[Docket No. 2001-SW-40-AD; Amendment 39-12793; AD 2002-13-05]

Airworthiness Directives; MD Helicopters, Inc. Model 369D, 369E, 369F, and 369FF Helicopters

ACTION: Final rule.

2002-13-05 MD Helicopters, Inc.: Amendment 39-12793. Docket No. 2001-SW-40-AD.

Figure 1 - Inspection Location

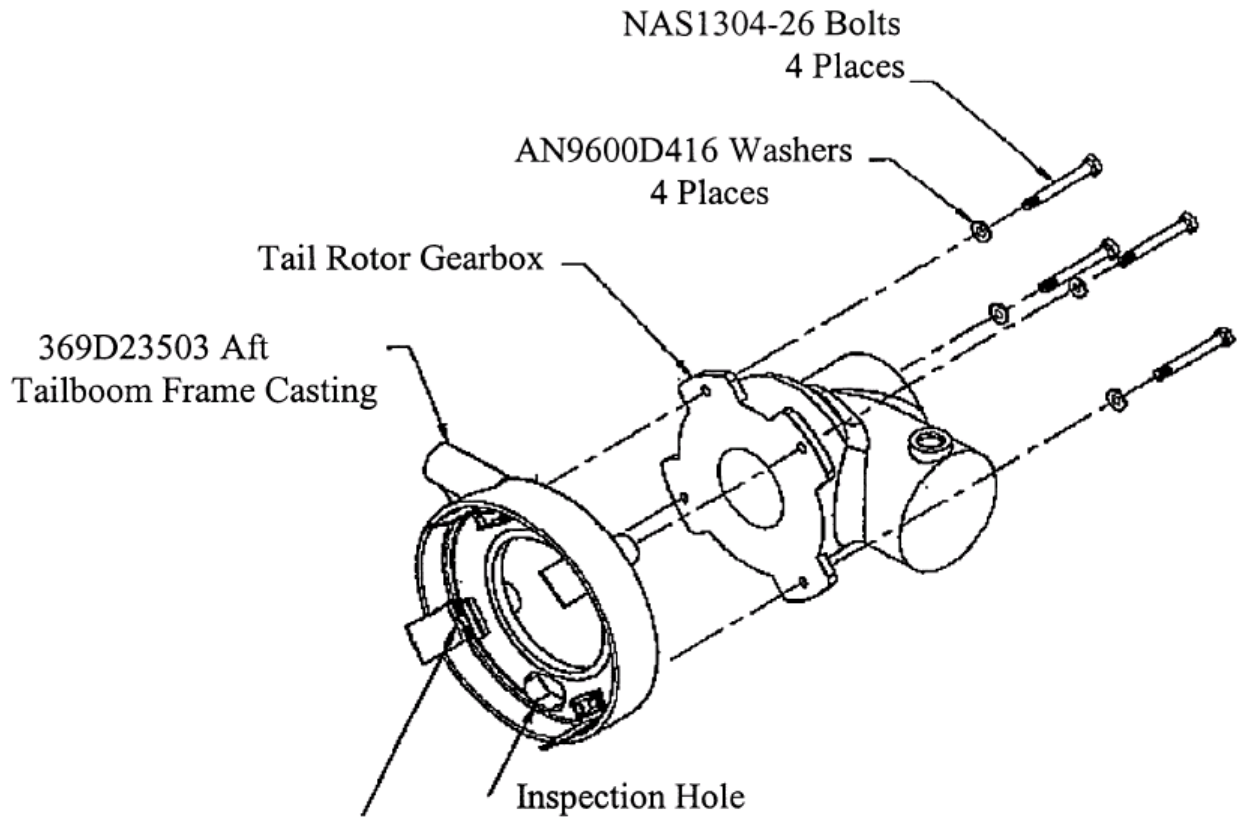
(2) Remove the tailboom control rod and determine the number of bolt threads protruding from each nutplate on the internal surface of the aft tailboom frame casting, P/N 369D23503, as shown in Figure 1 of this AD. At least one thread must protrude. If more than four threads protrude, add an additional washer, P/N AN960D416, under the bolt head. Torque the bolt to 100-110 in-lbs, and reapply a slippage mark. See Figure 1:

Inspect this area of each bolt.
 Bolt must protude at least one
 thread past end of nutplate
 4 places.
